RFI #: 163 Date: 6/26/2012 Job: EB-02 Keller Springs Lofts Phone: 877-777-5115

Subject: Steel Beam at SW Corner of Fitness

Subject: Support for Exterior Wall Above Fitness/Club Patio

Subject: Steel Beams Located in Exterior Walls

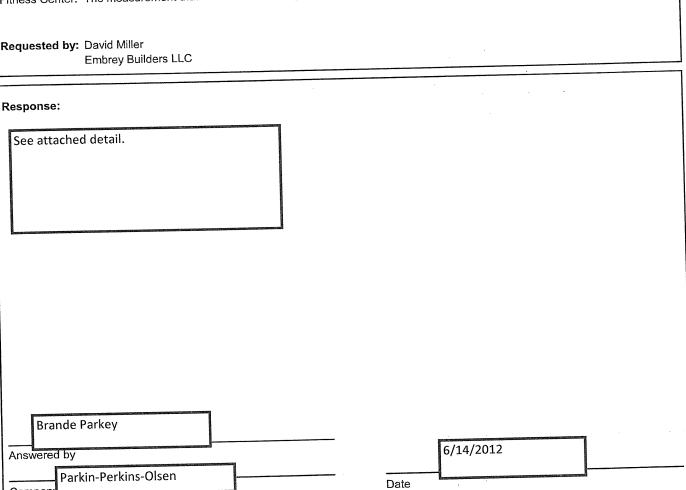
Spec Section: Drawing: S2.21 Schedule Impact: None Cost Impact: None Date Required: 6/8/2012 Based on our discusson on 5/30/12 conference call, please provide a method to support the exterior wall above the patio at the Fitness Center. The measurement that the framer came up with was 5 1/2 inches that would need to be padded out. Requested by: David Miller Embrey Builders LLC
